Project Title:	GYSBI SHORE BASE	Scale:	Scaled to fit	Date:	2024.03.27
Project Location:	Houston District, Greater Georgetown	Request/Surveyed by:	SLC Ops.Man. Maintenance		*****
Drawing Title:	VESSEL PLATFORM/STAIRS	Drawing by:	A.Flatts	Drawing #:	VPS-A-101
		Checked by:	I.Baksh B.Murli	Page No:	01
		Approved by:		Appr. Date:

Project Title:	GYSBI SHORE BASE
Project Location:	Houston District, Greater Georgetown
Drawing Title:	VESSEL PLATFORM/STAIRS

NOTE: All weld connection must be full welds unless otherwise stated.

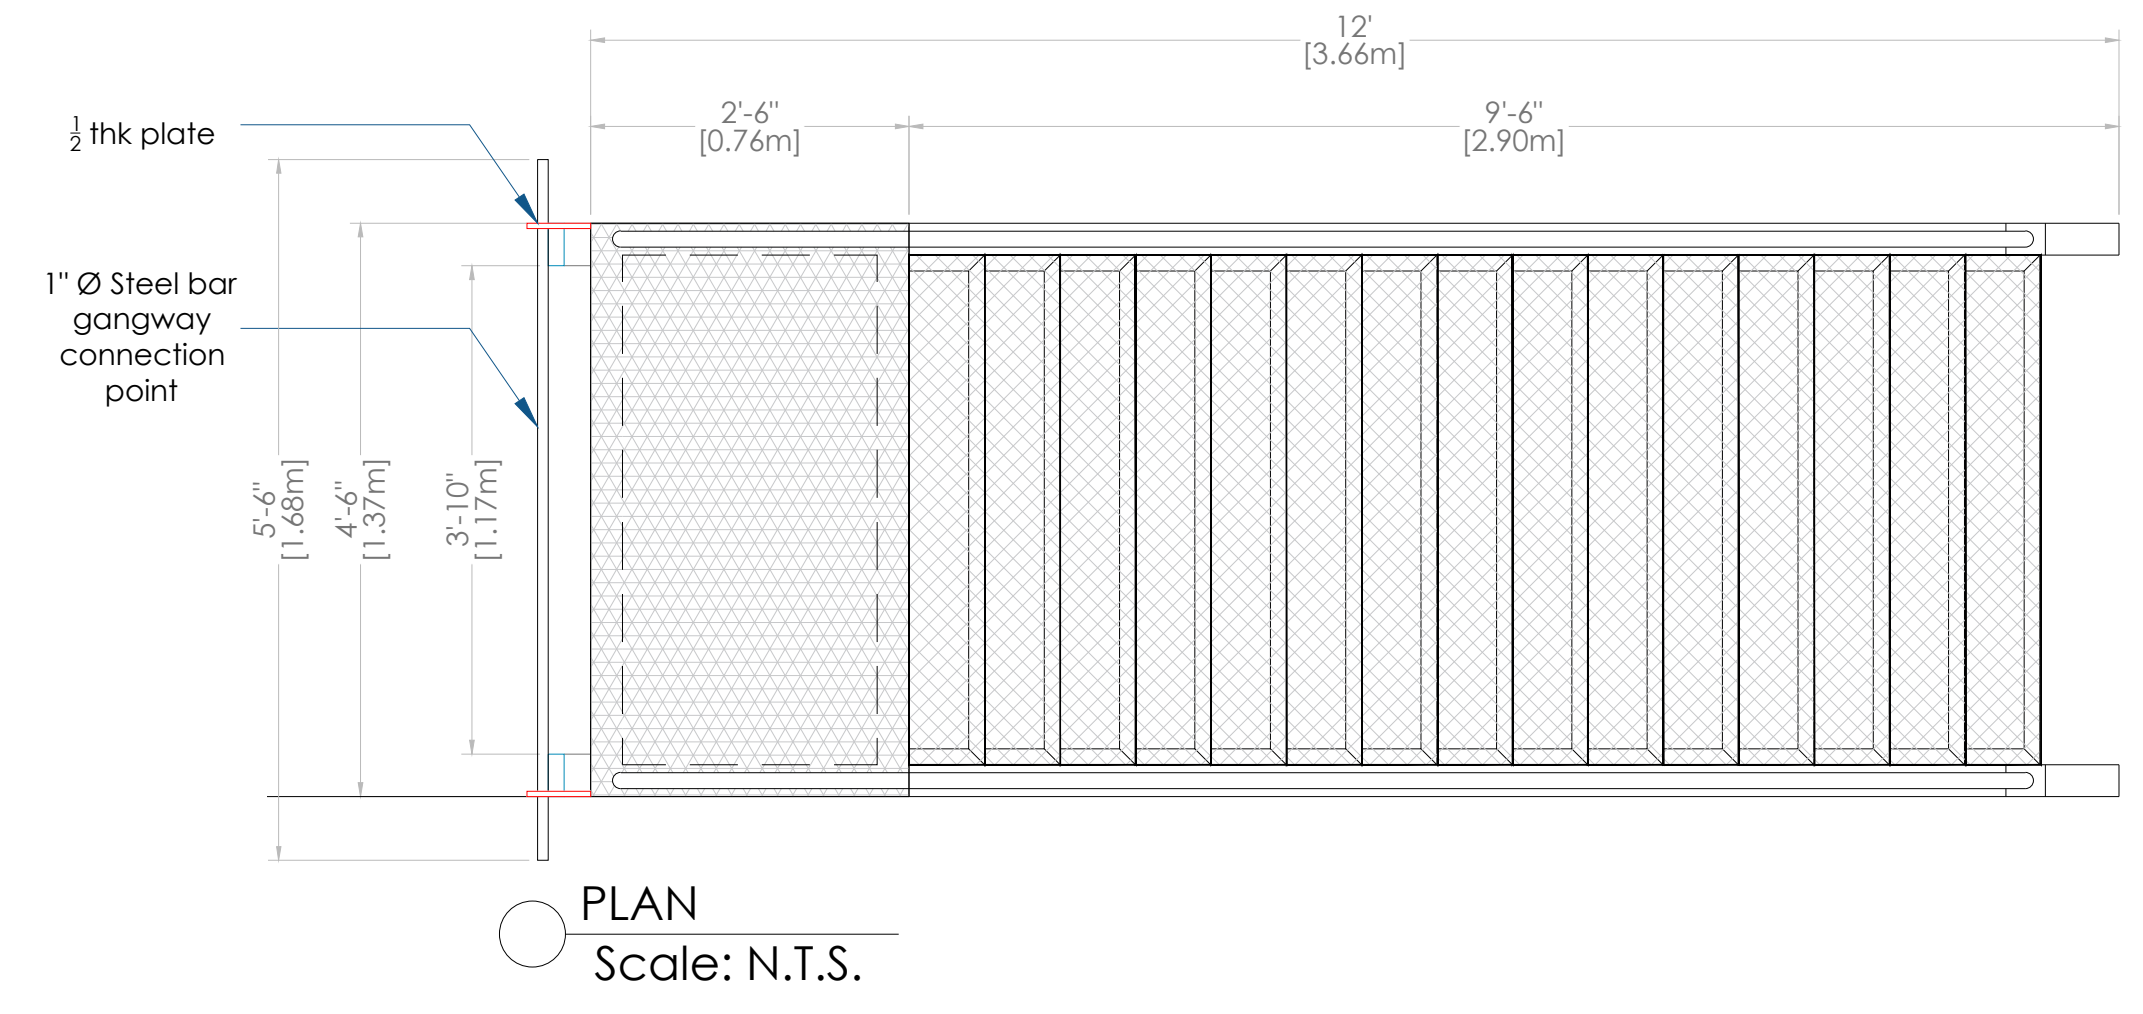
No.	REVISION	DATE	CLIENT
3	Stair lifting design update. 1" thk x 3" wide plate with 1.75" dia. lifting eye, welded to stringer frame and extended thru angled section about 5". Update reflects changes in "lifting eyes" on the stair stringer only. Other elements remain the same.	2024.03.26

Scale:	Scaled to fit	Date:	2024.04.02
Request/Surveyed by:	SLC Ops.Man. Maintenance	*****	
Drawing by:	A.Flatts	Drawing #: VPS-A-102	
Checked by:	I.Baksh B.Murli	Page No: 02	
Approved by:		Appr. Date:

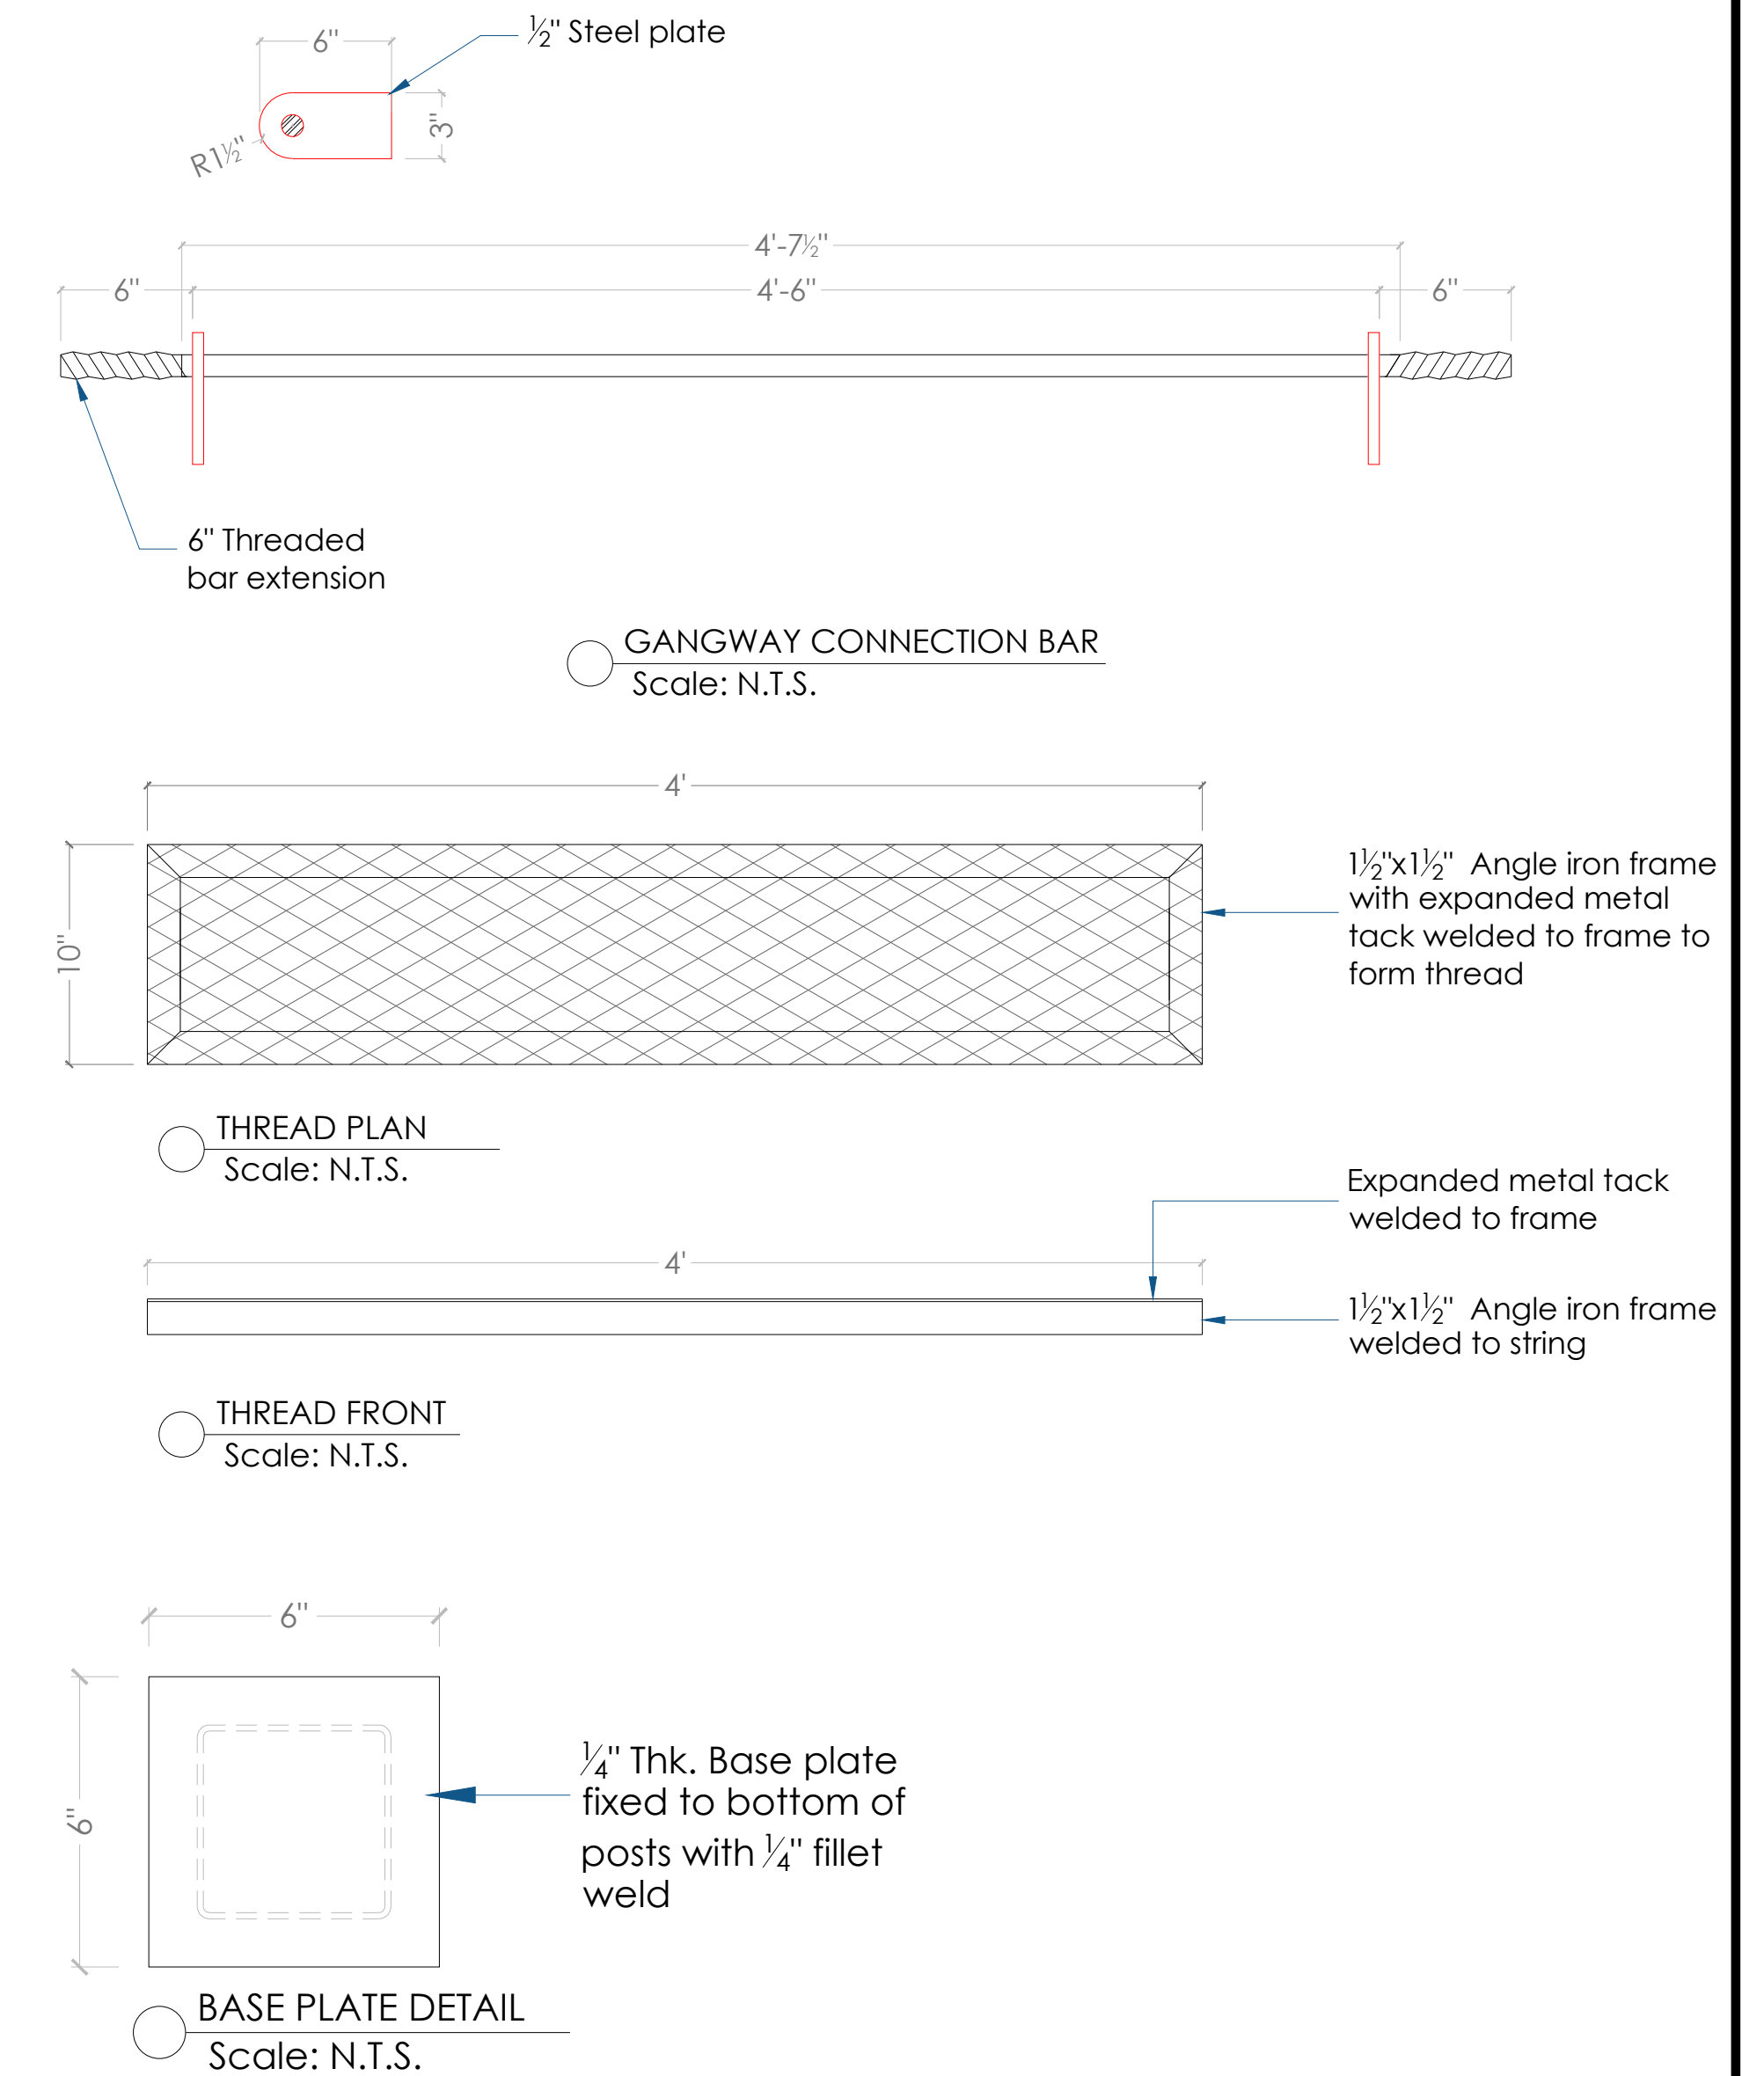
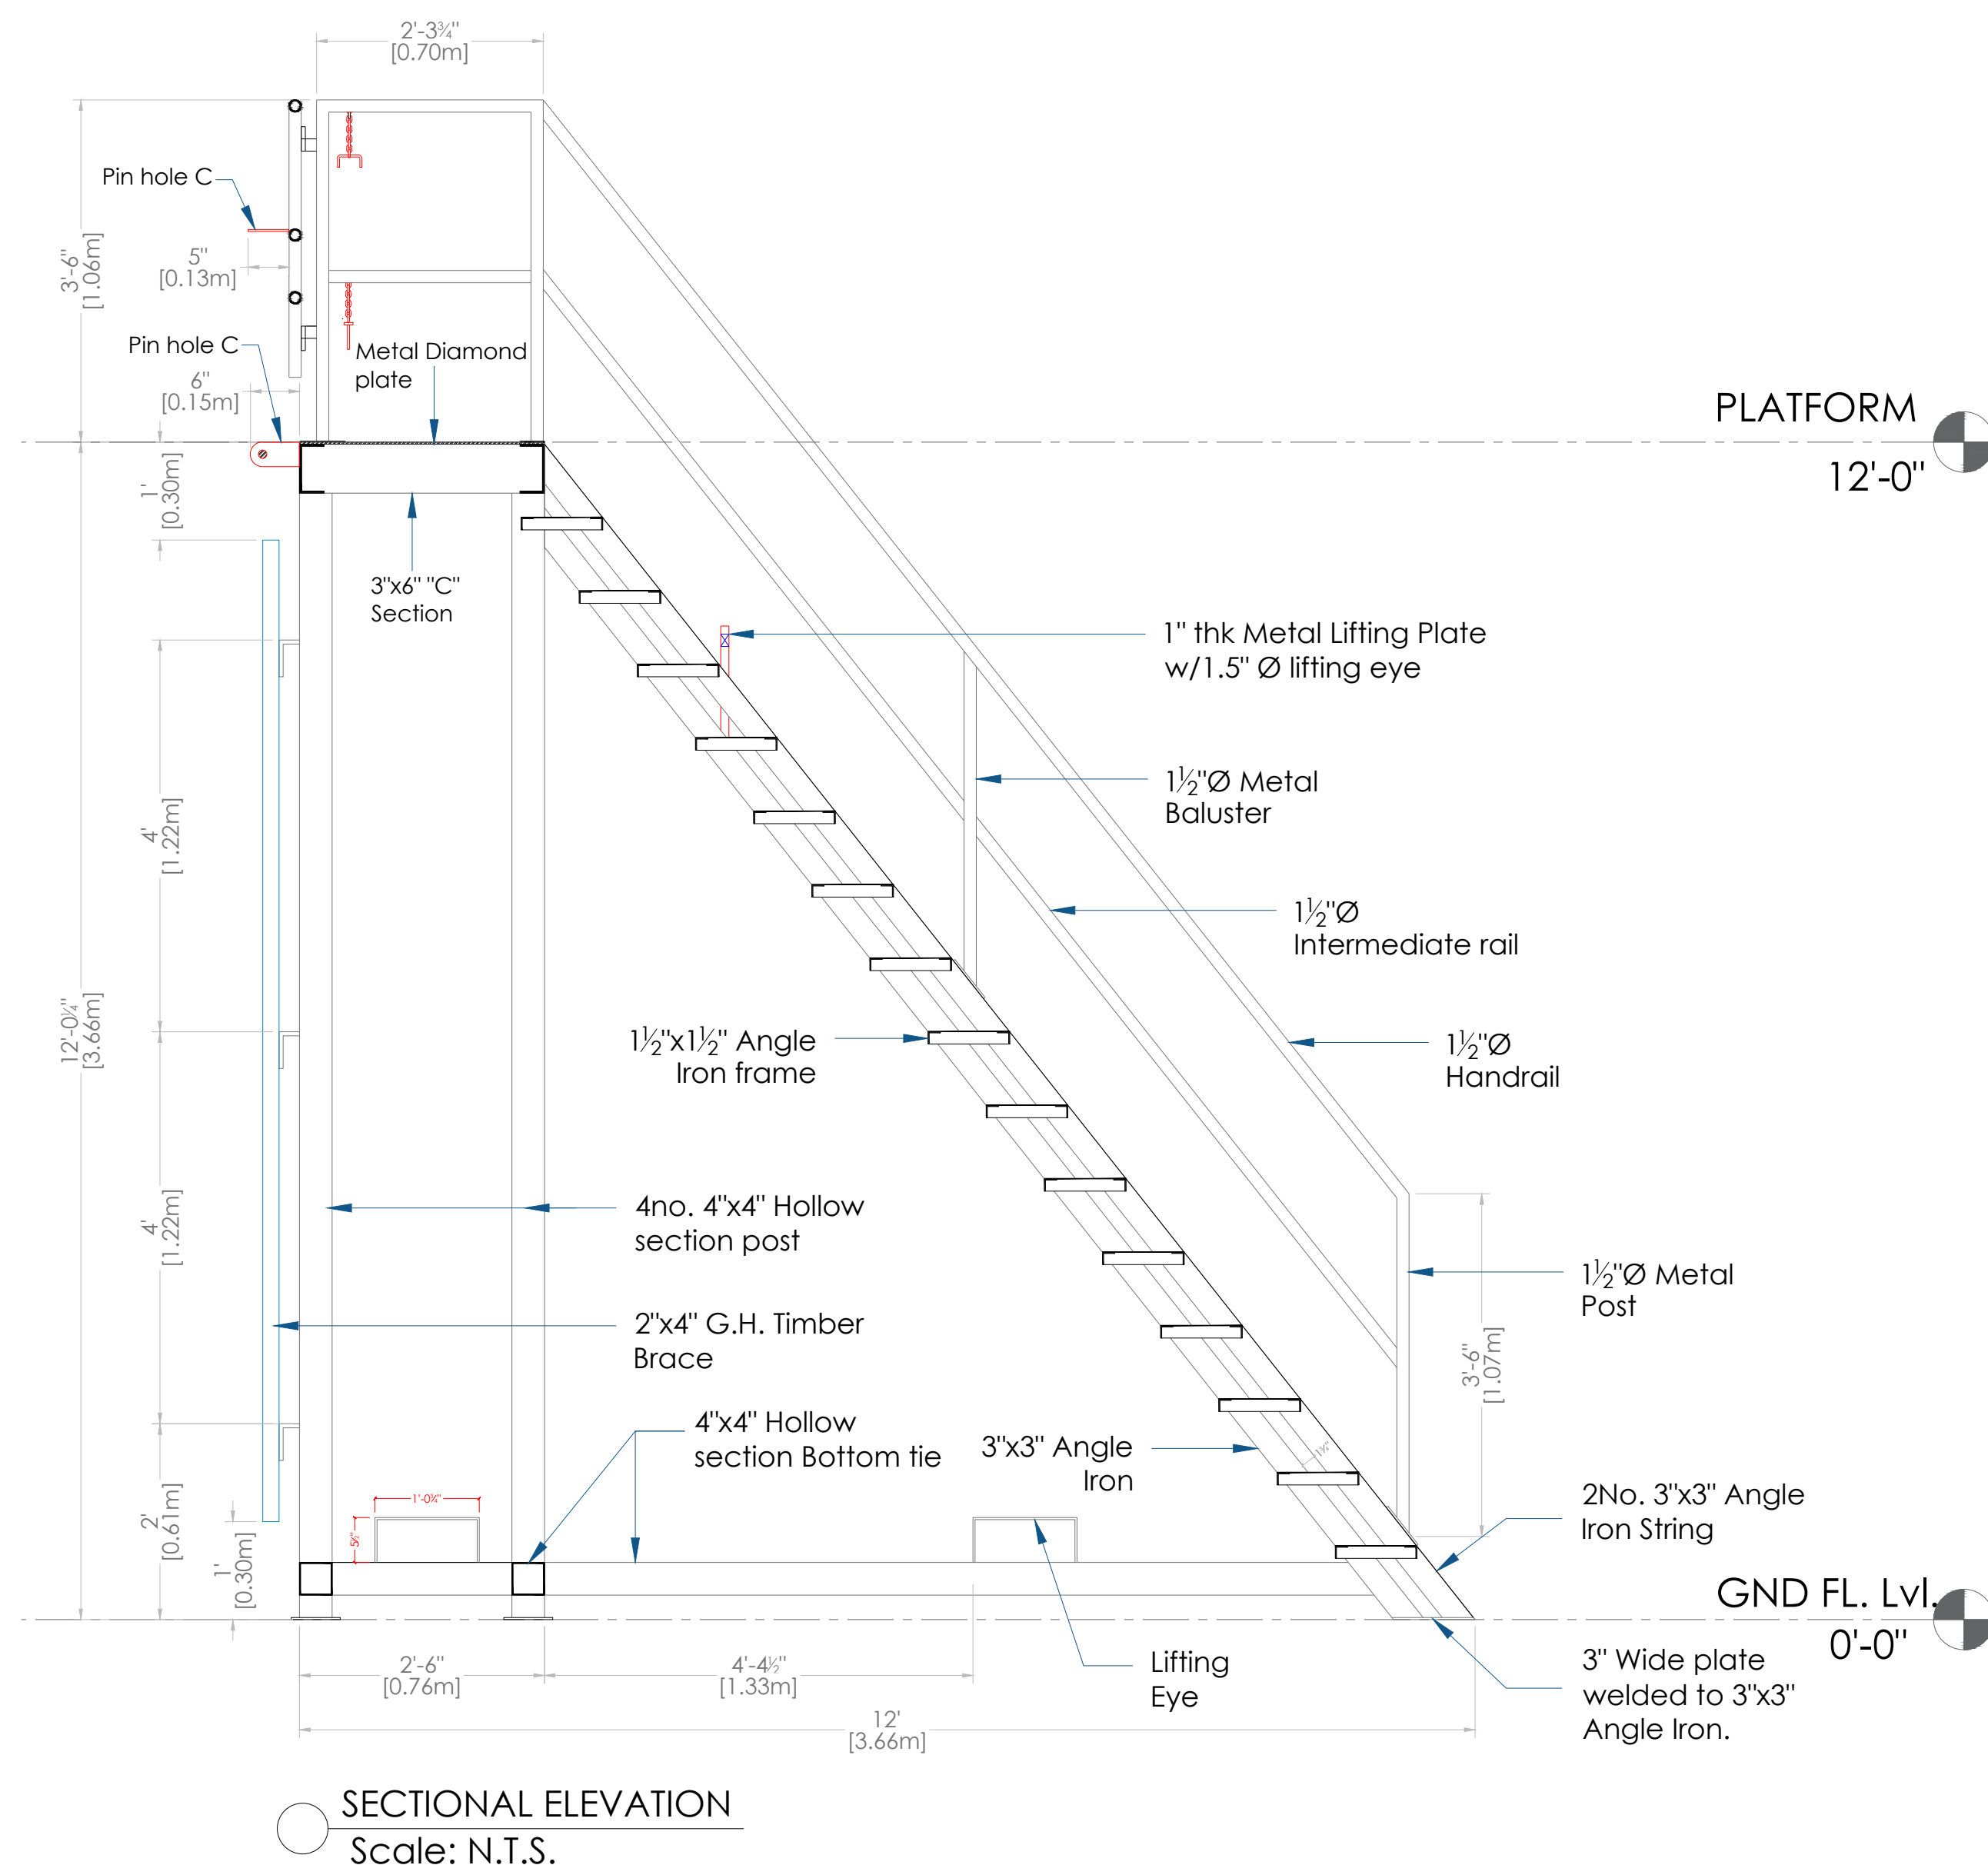
No:	REVISION	DATE:	CLIENT:
3	Stair lifting design update. 1" thk x 3" wide plate with 1.75" dia. lifting eye, welded to stringer frame and extended thru angled section about 5". Update reflects changes in "lifting eyes" on the stair stringer only. Other elements remain the same.	2024.03.26
